OXFORDSHIRE COUNTY COUNCIL'S RESPONSE TO CONSULTATION ON THE FOLLOWING DEVELOPMENT PROPOSAL

Application no: 21/04171/F

Proposal: Re-development of part of existing car park to provide a drive-thru cafe within Use Class E; together with associated car parking, servicing and access; landscaping and all associated works

Location: Jacobs Douwe Edberts, Ruscote Avenue, Banbury

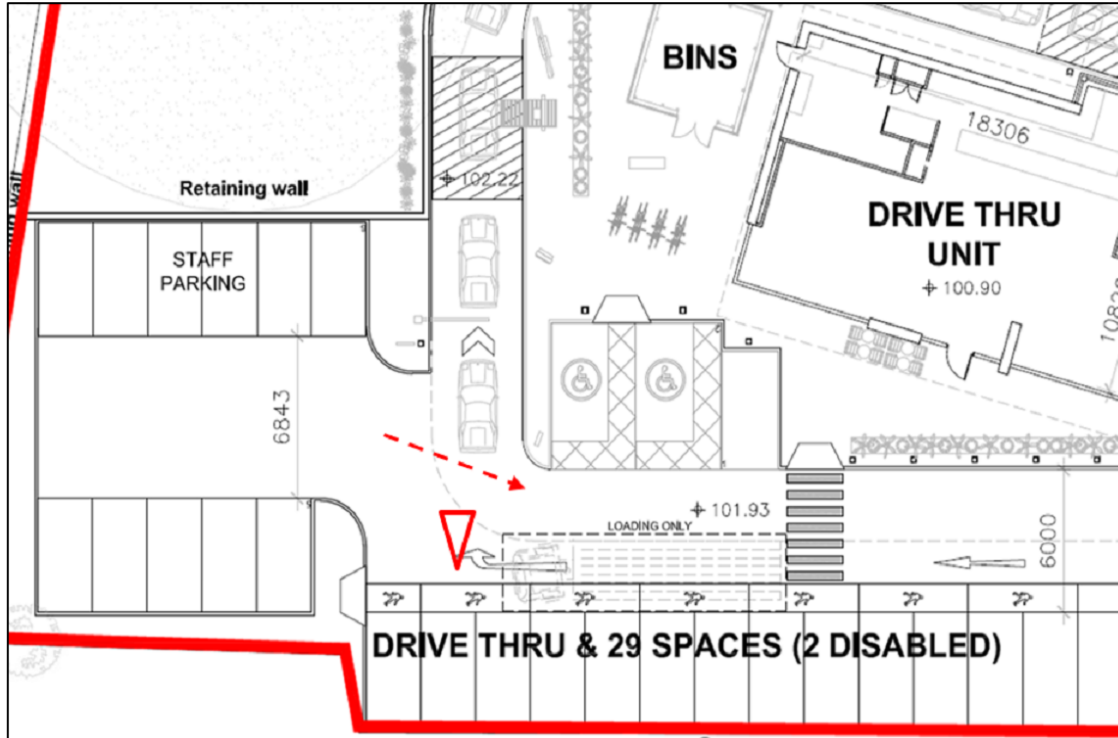
There appears to be a potential conflict point where drivers may not know who has right of way. The layout needs to make it clear possibly by give-way markings to allow vehicles from parking spaces further south to exit with priority over those heading into the drive-thru. See illustration below.

I am left concerned that such an arrangement may lead to arriving vehicles backing back onto Ruscite Avenue which has not been carefully considered.
